ADDENDUM NO. 2

**New Premium 63 Site Loop Campground
St. Francois State Park
Bonne Terre, Missouri
PROJECT NO.: X2317-01**

August 29, 2025

SHEET TITLE:
**ELECTRICAL
SITE PLAN**

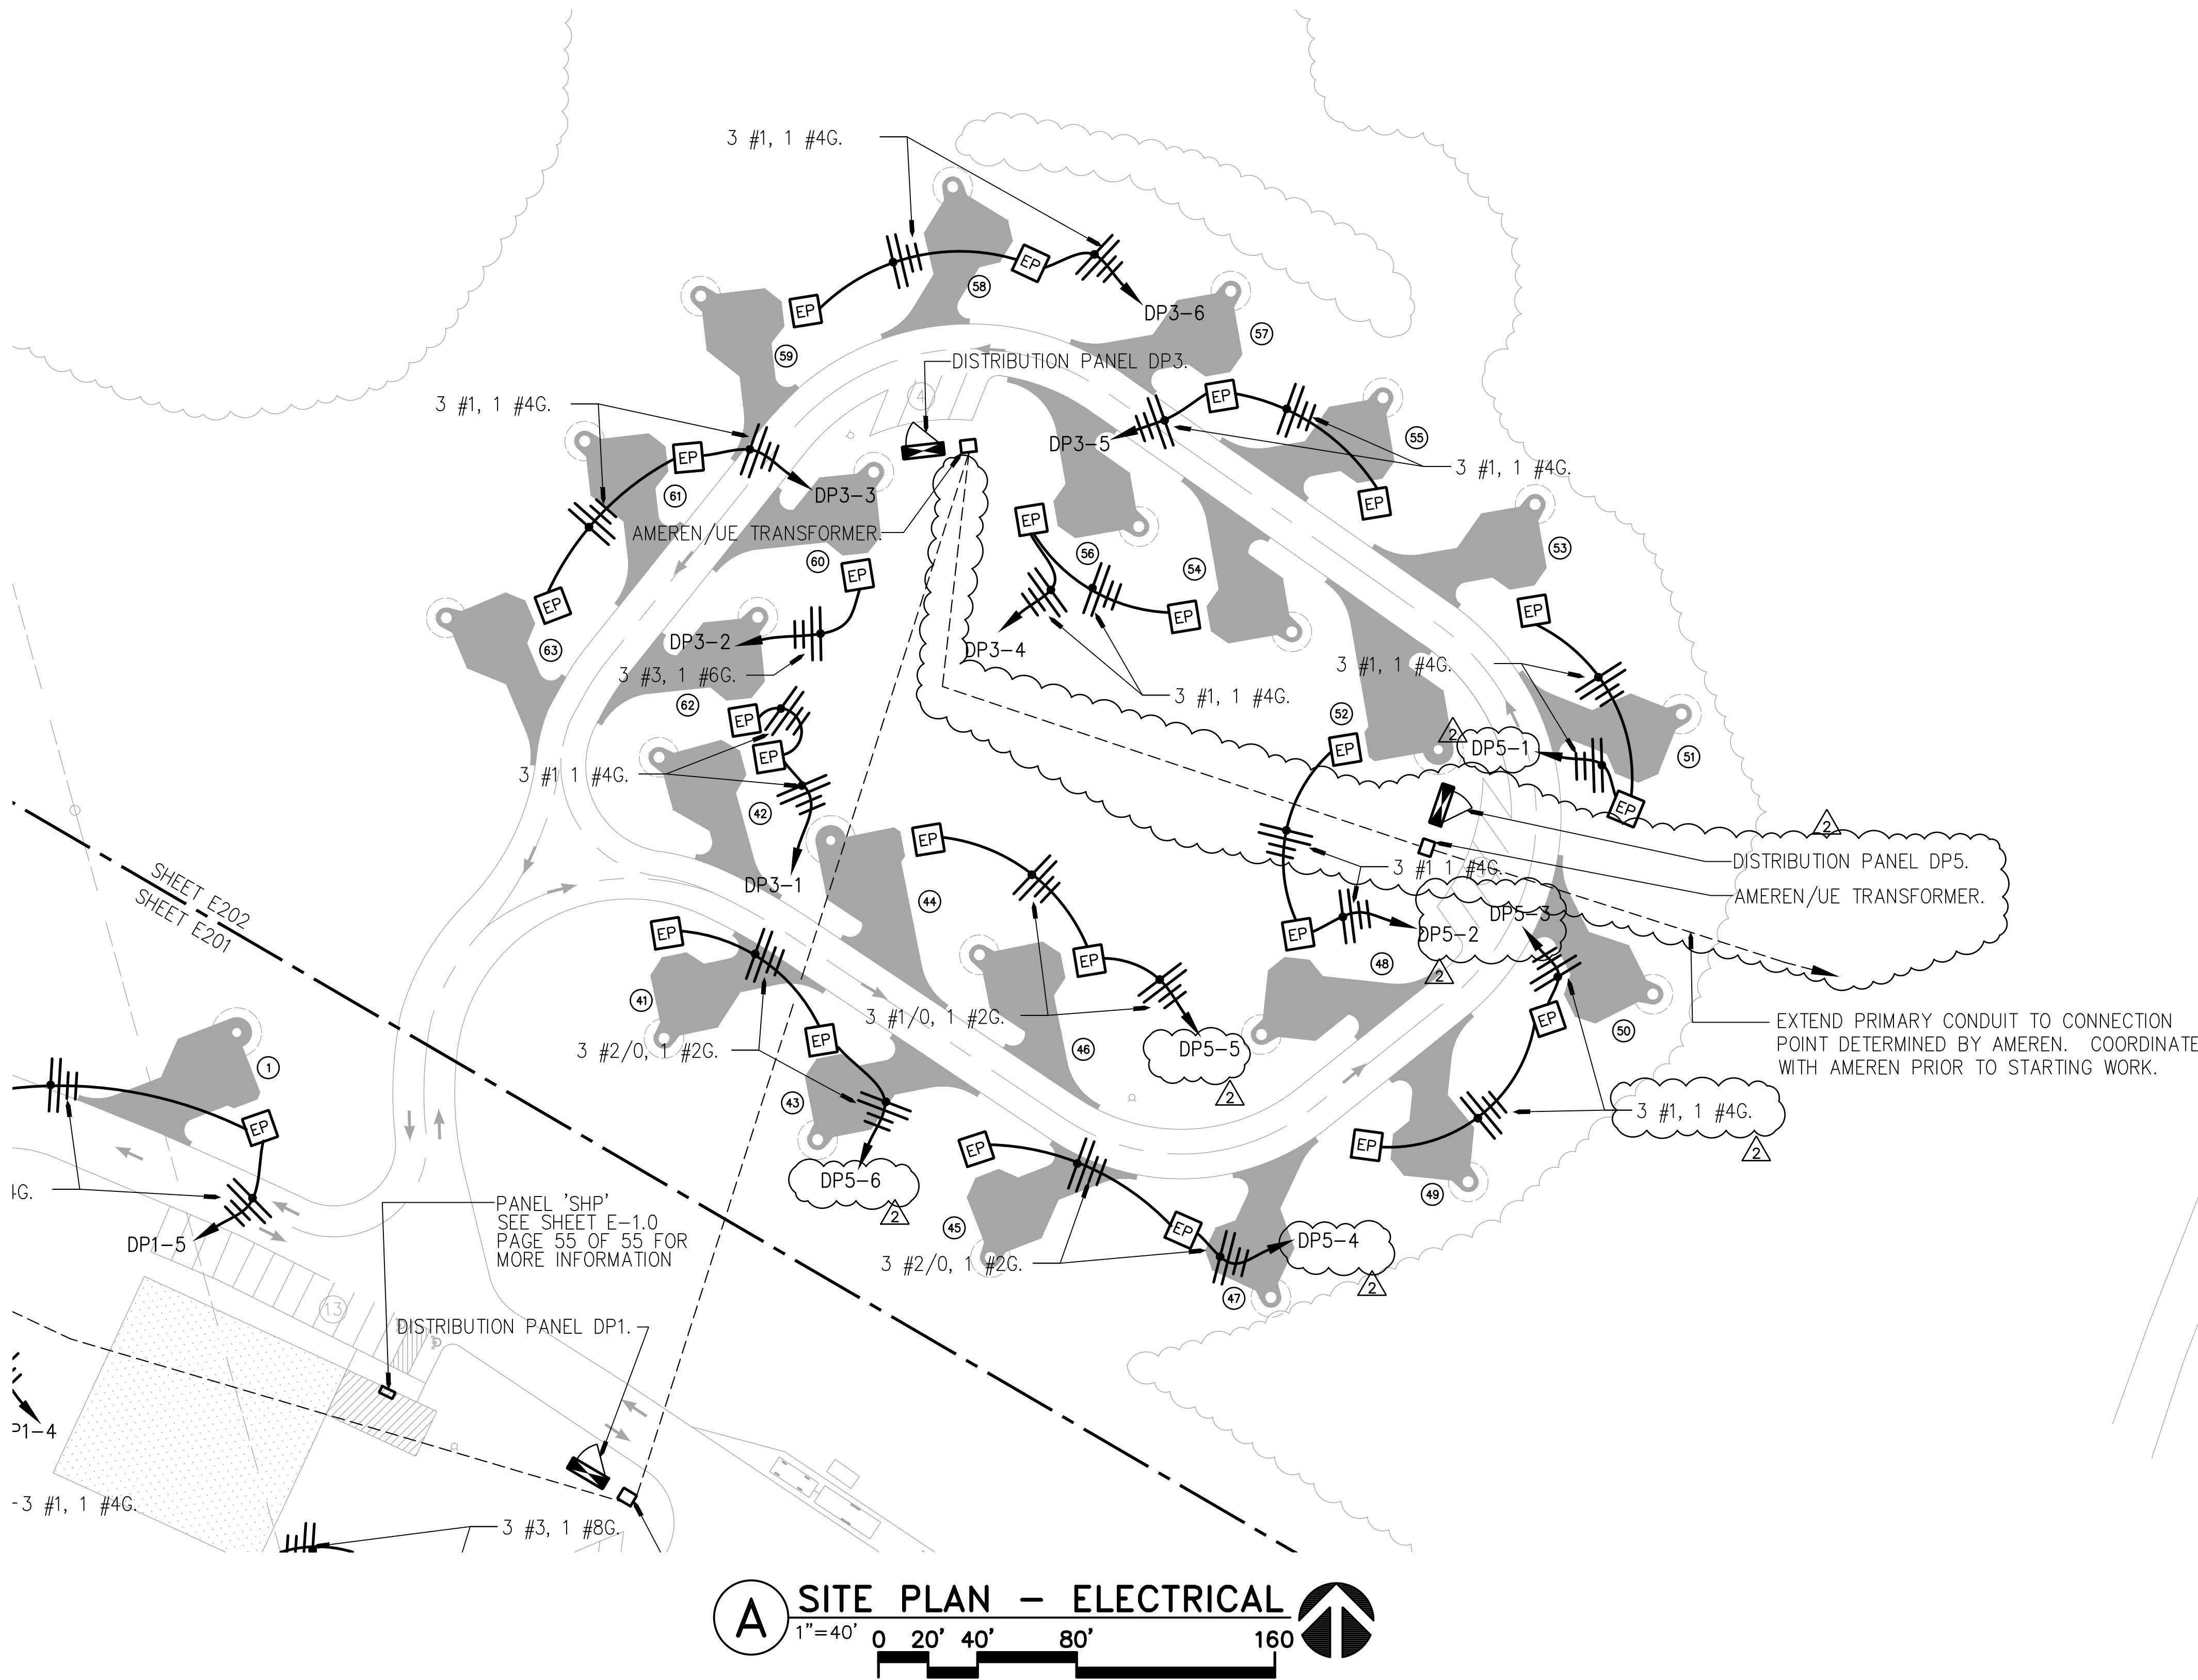
1. Added additional transformer and distribution panel DP4.
2. Moved circuiting from panels DP1 and DP2 to new panel DP4.
